ADC PARKS & GREENSPACE ARBORICULTURE

PLANNING APPLICATION: A/113/15/PL

ADDRESS: Premier Inn Spinney and Burberry House Roundstone Lane /
Roundstone Road East Preston Angmering BN16 1EB

BRIEF DESCRIPTION: Demolition of "Spinney" and "Burberry House" and
erection of two-storey hotel annexe with associated car parking. Re-Submission
following A/50/15/PL

Figure 4 Diagrammatic illustration of crown reduction

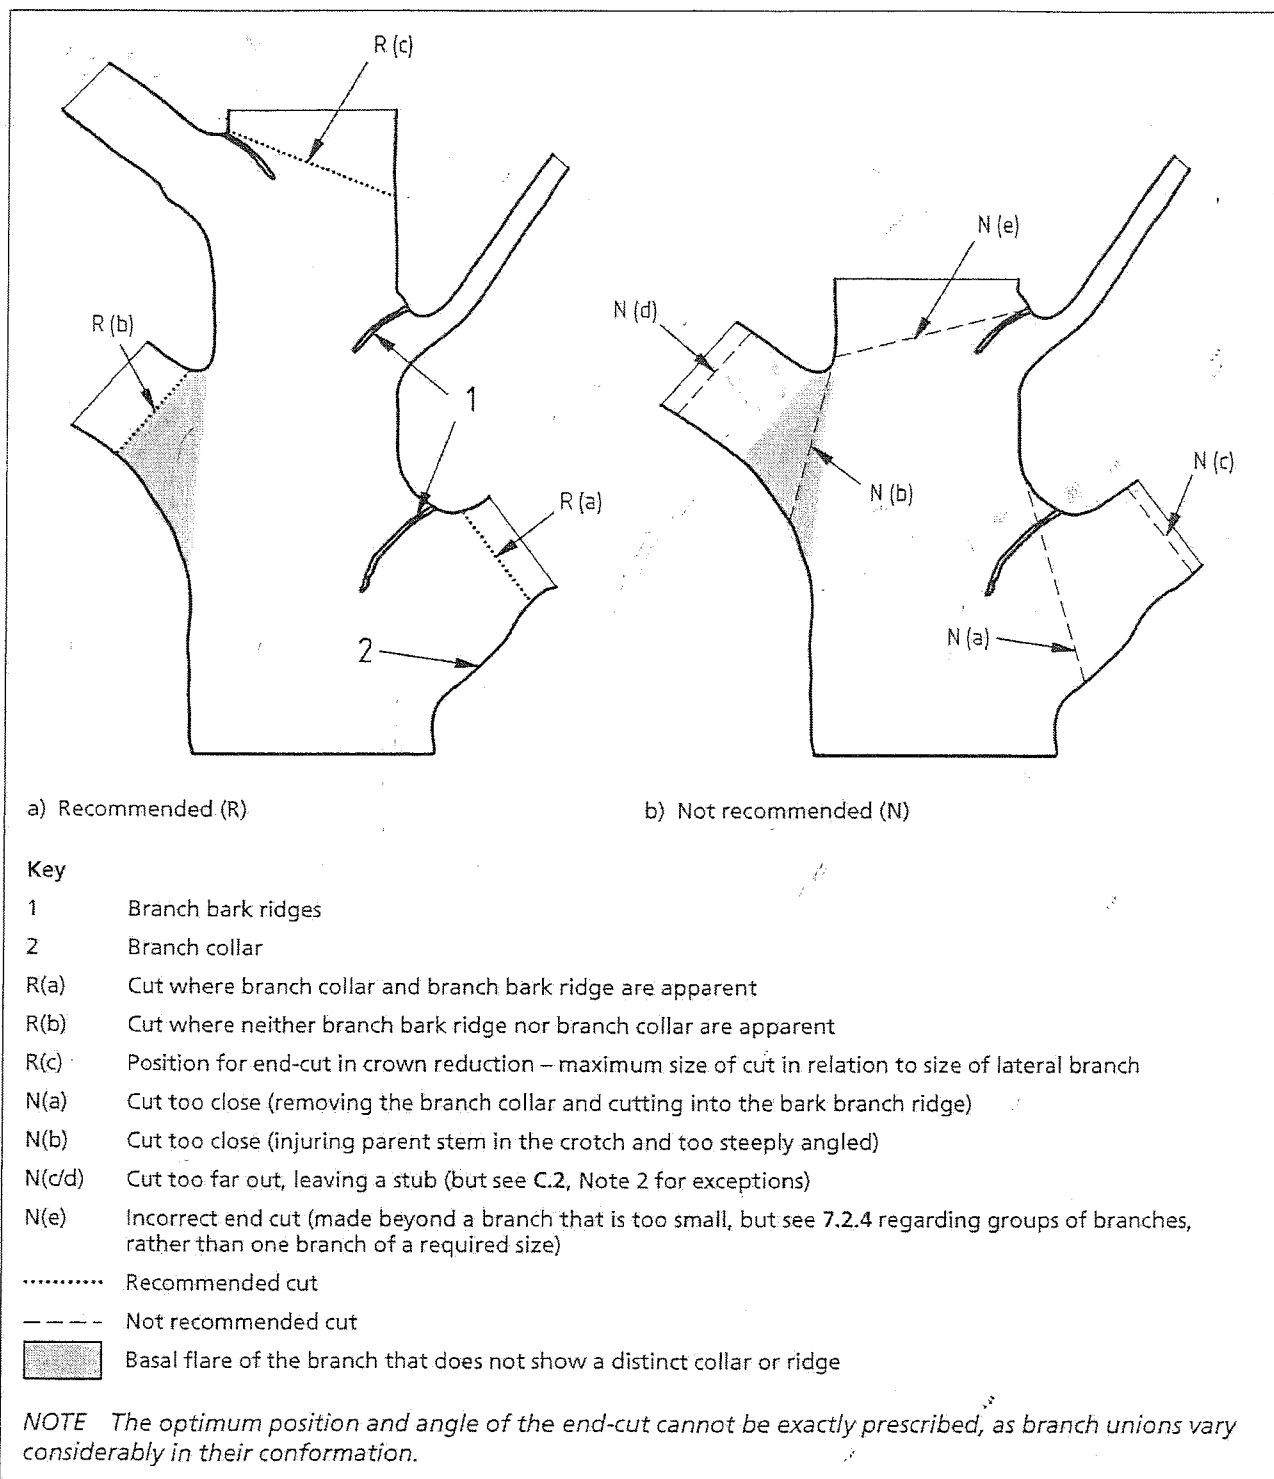
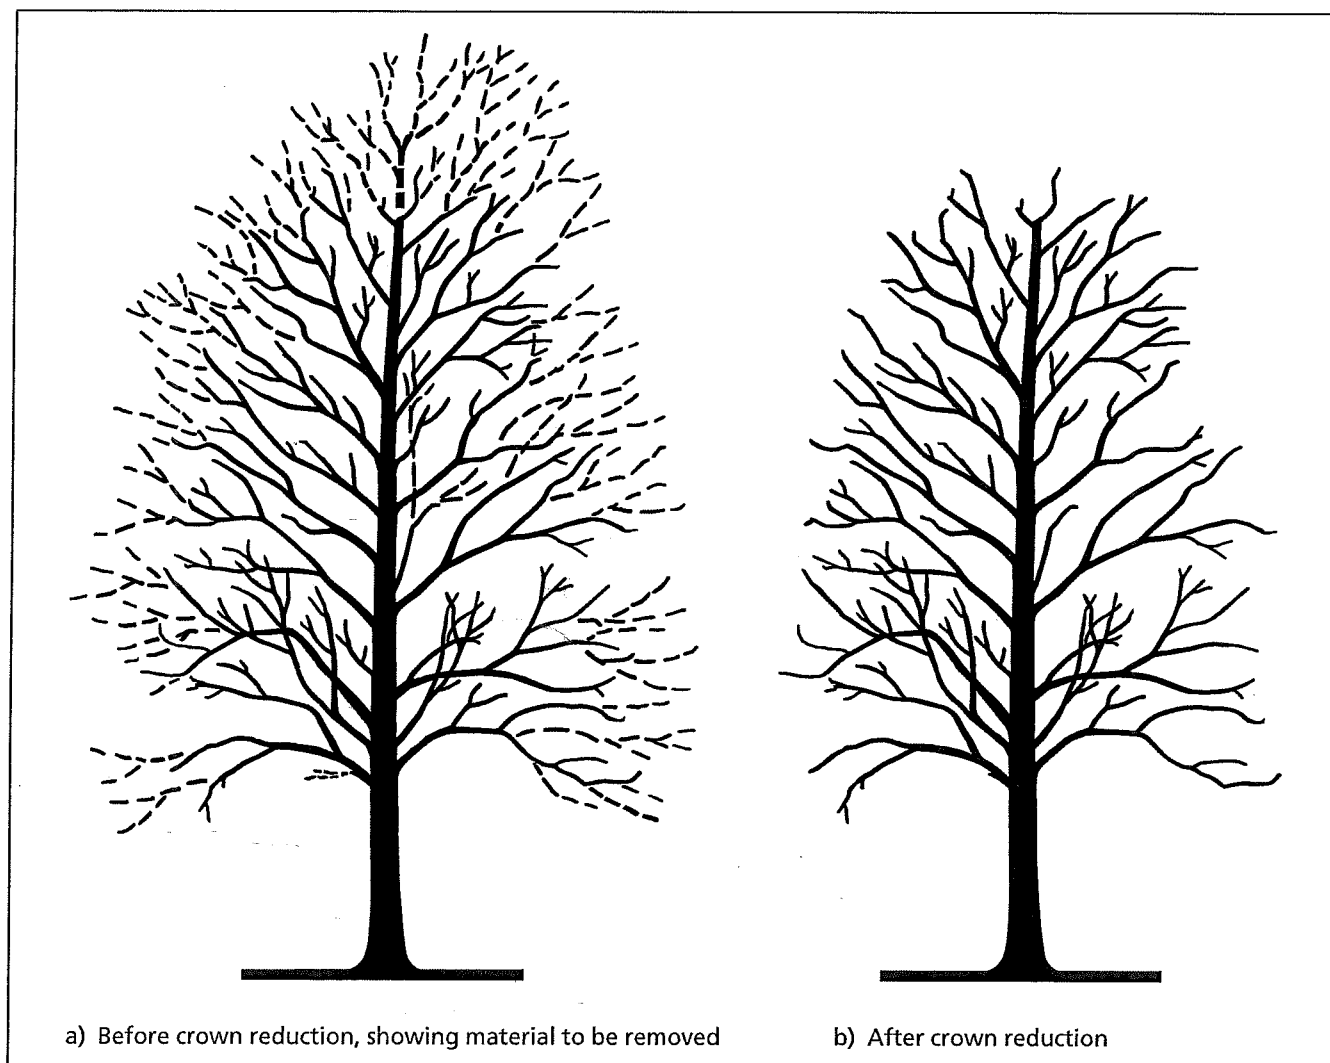
Pruning Works conditions for T5;

Crown Reduction

- All side branches to be retained should be at least **1/3rd** in diameter of the removed branch. Pruning cuts must be flat and smooth, kept as small as possible by cutting at an optimum angle and should not exceed **100mm** in diameter.

Figure 2 Default specification for protective barrier

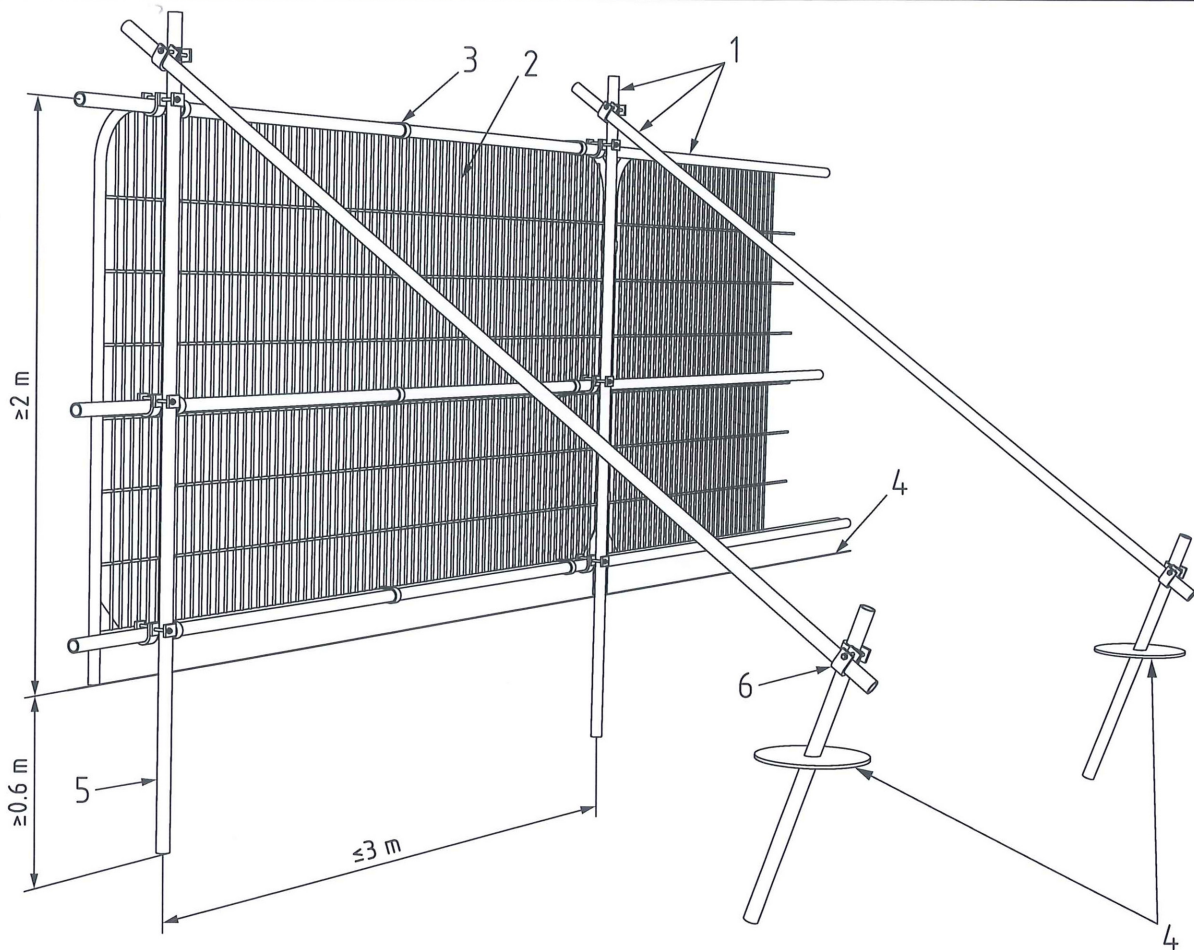
- The implication of effective ground protection must be achieved before any construction works commences. This protective fencing must be erected and kept in place for the duration of the development works. this would applied to **T16, T17, T18, T25 and T28**

- Once the protective fencing has been erected, the Local planning authority arboricultural officer must be contacted to ensure the fencing is correctly placed. This fencing must be erected and kept in place for the duration of the development works.
